FINAL DRAINAGE LETTER FOR LOT 5 OF CLAREMONT BUSINESS PARK 2 FILING NO. 1

Project #44-037
PCD – PPR-2031

RE: Drainage Letter for Lot 5 of Claremont Business Park 2 Filing No. 1

EL PASO COUNTY, STATE OF COLORADO
GRADING & EROSION CONTROL PLAN

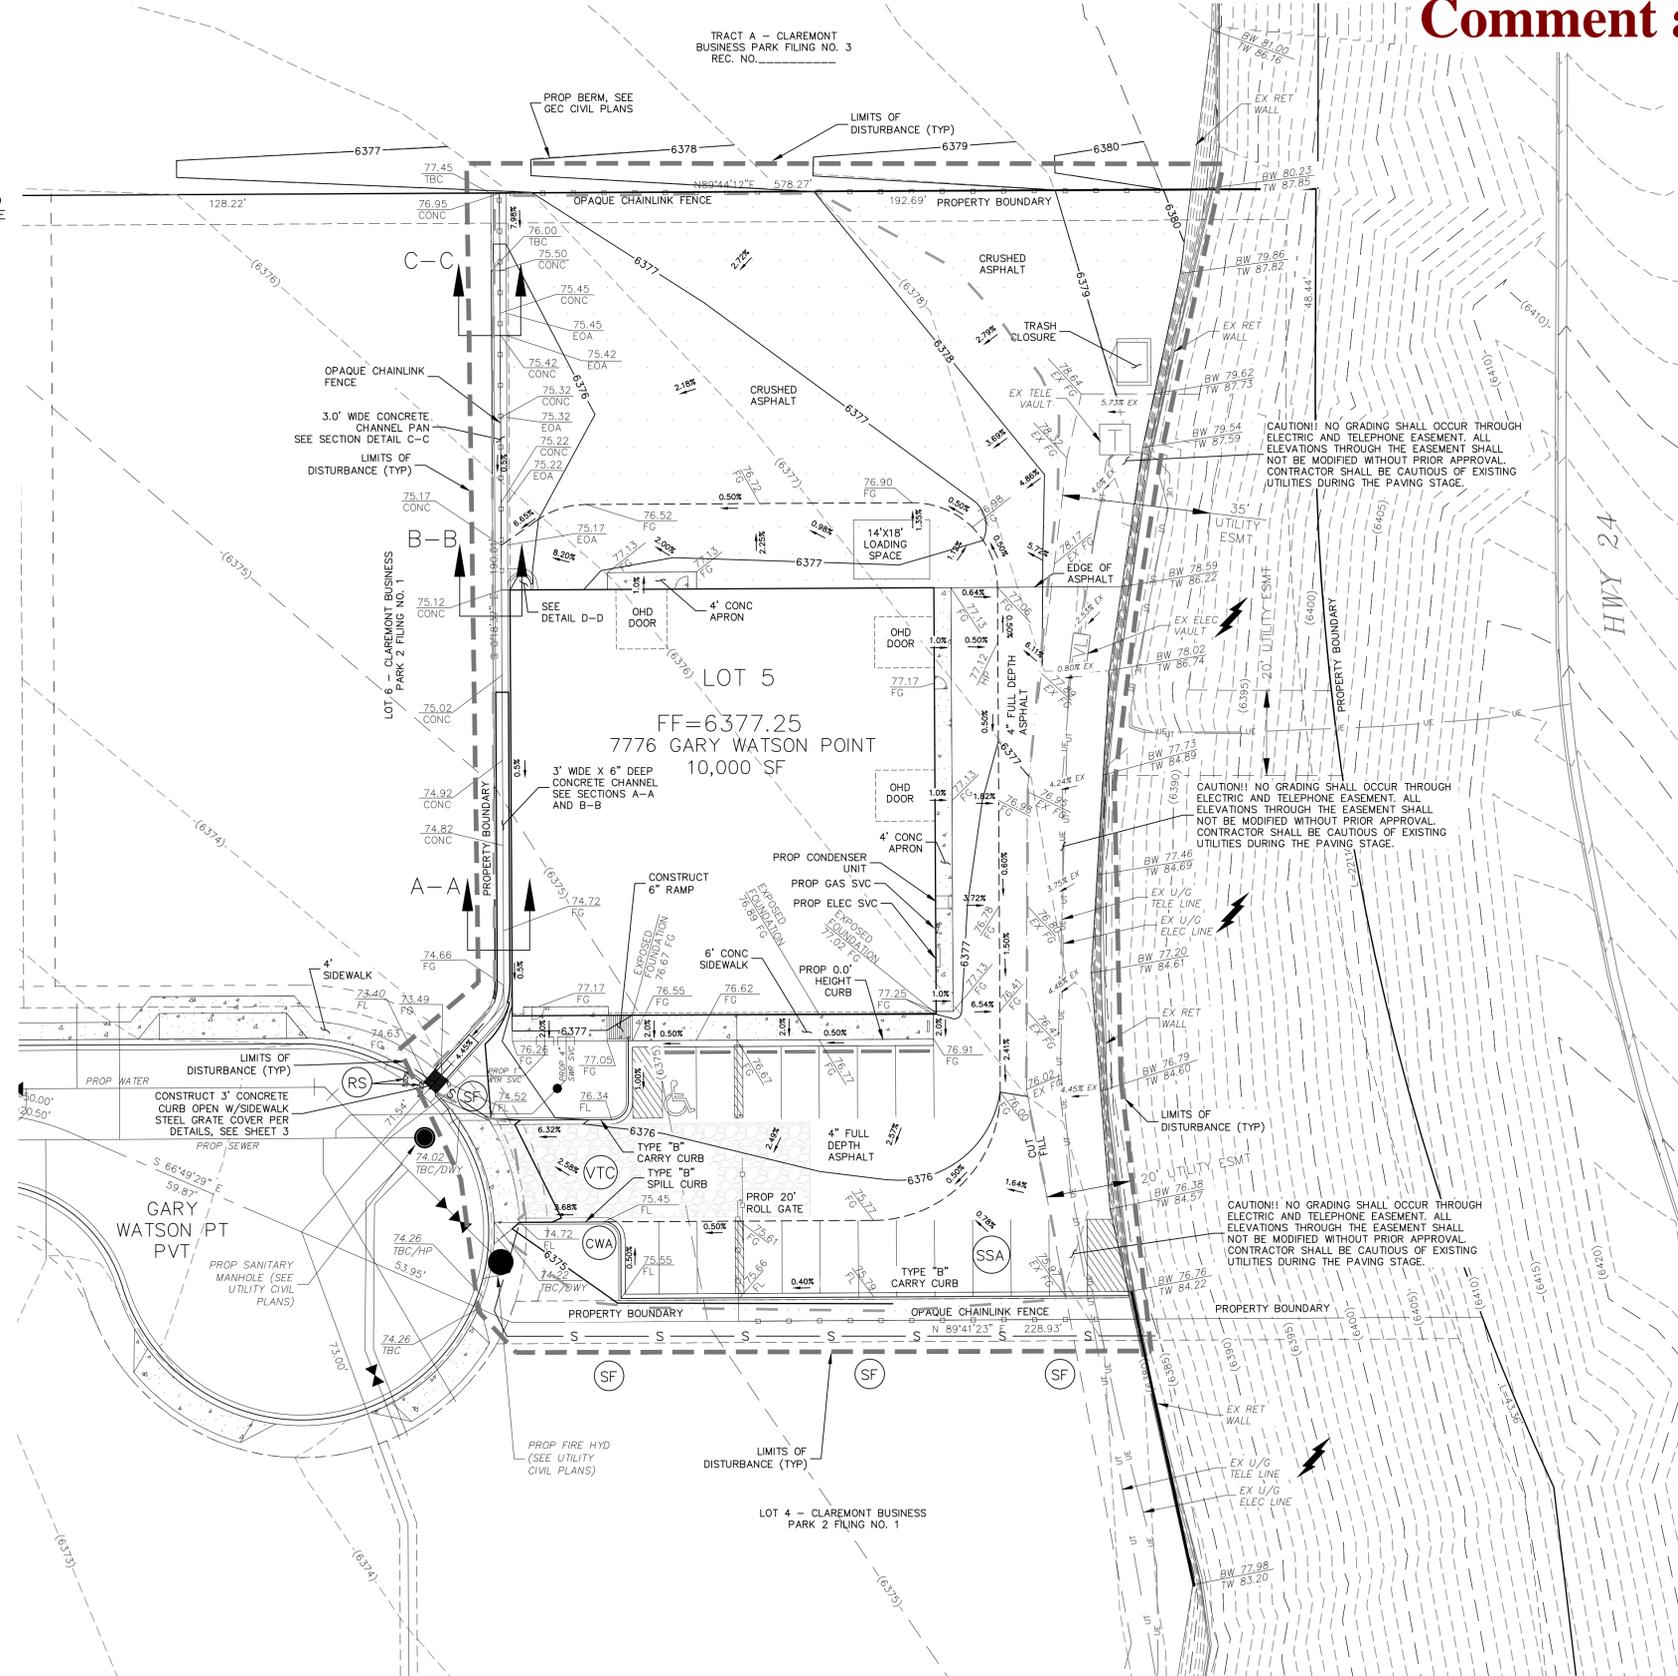
Please stamp as "For Reference Only"

Comment addressed.

EL PASO COUNTY, STATE OF COLORADO
GRADING & EROSION CONTROL PLAN

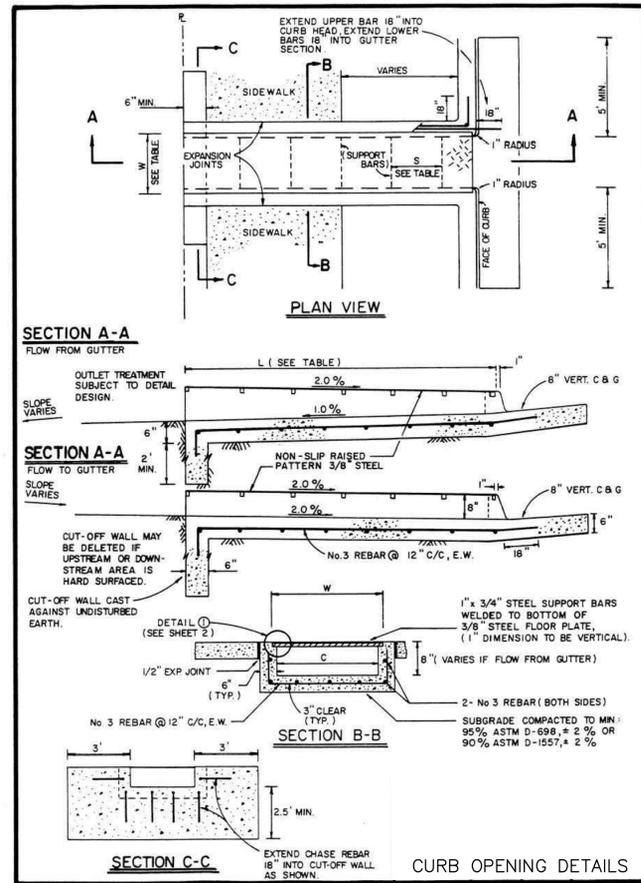
Please stamp as "For Reference Only"

Comment addressed.

FINAL PLAT
CLAREMONT BUSINESS PARK 2
FILING NO. 1
JOB NO. 44-037
DATE PREPARED: 04/28/2020
DATE REVISED: 10/21/2020

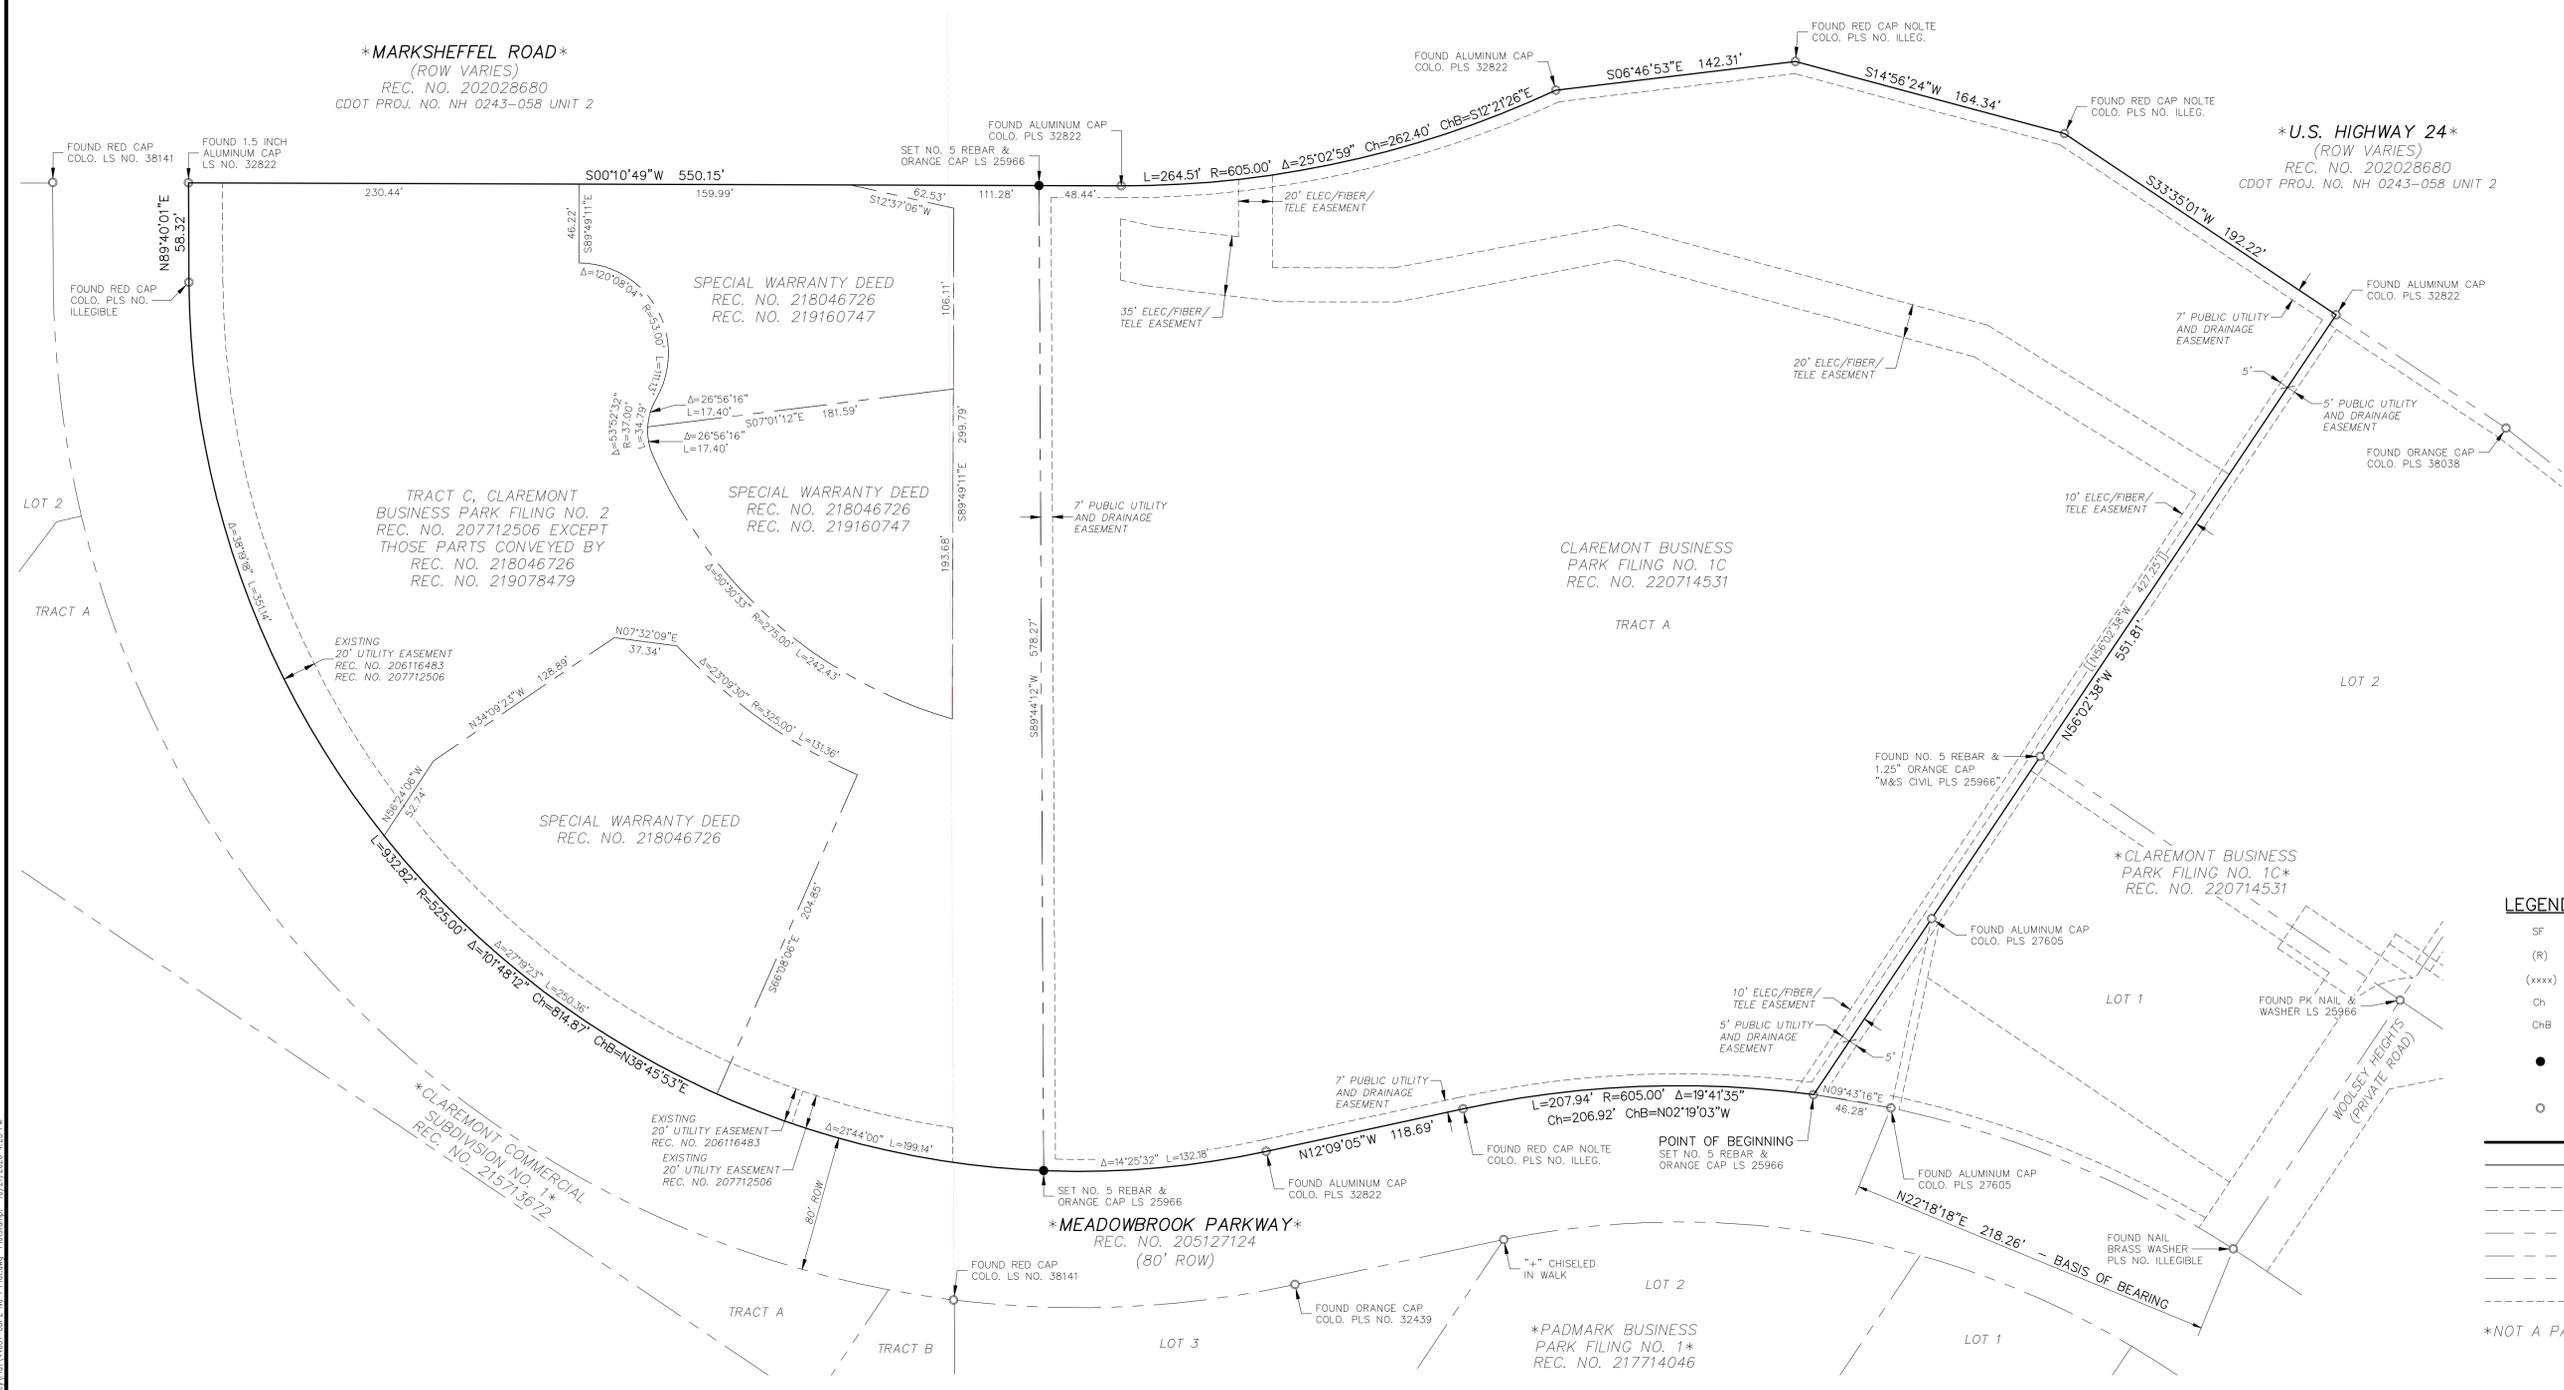
Please stamp as "For Reference Only"

Comment addressed.

AS REPLATTED

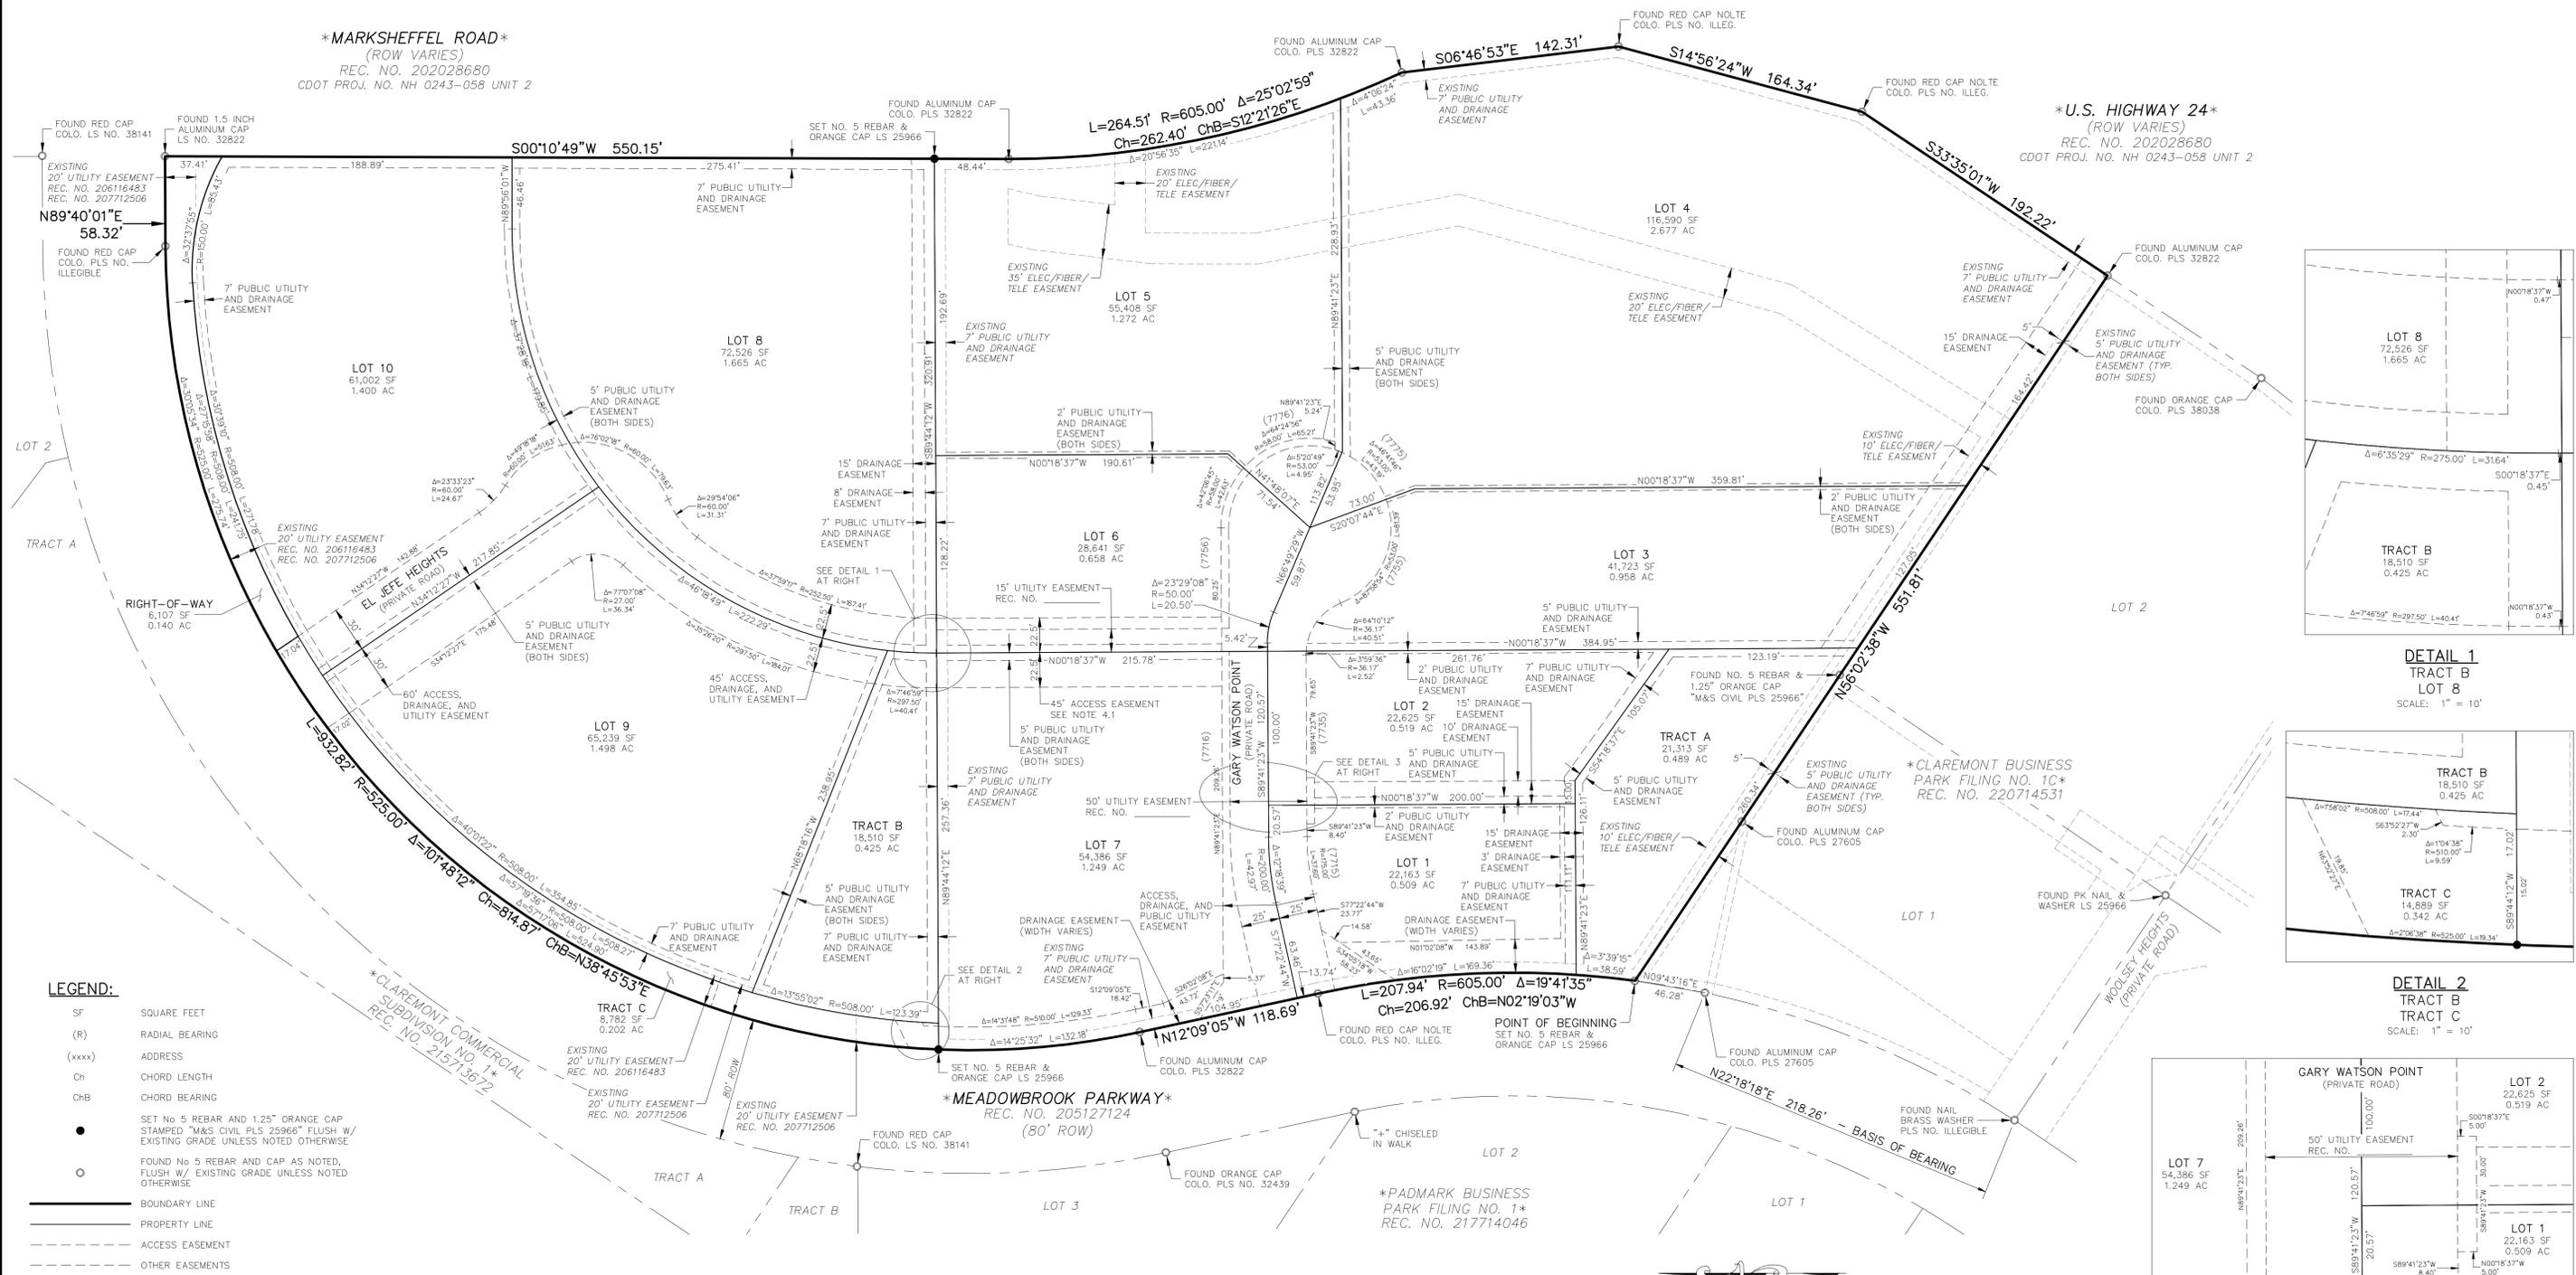
Please stamp as "For Reference Only"

Comment addressed.
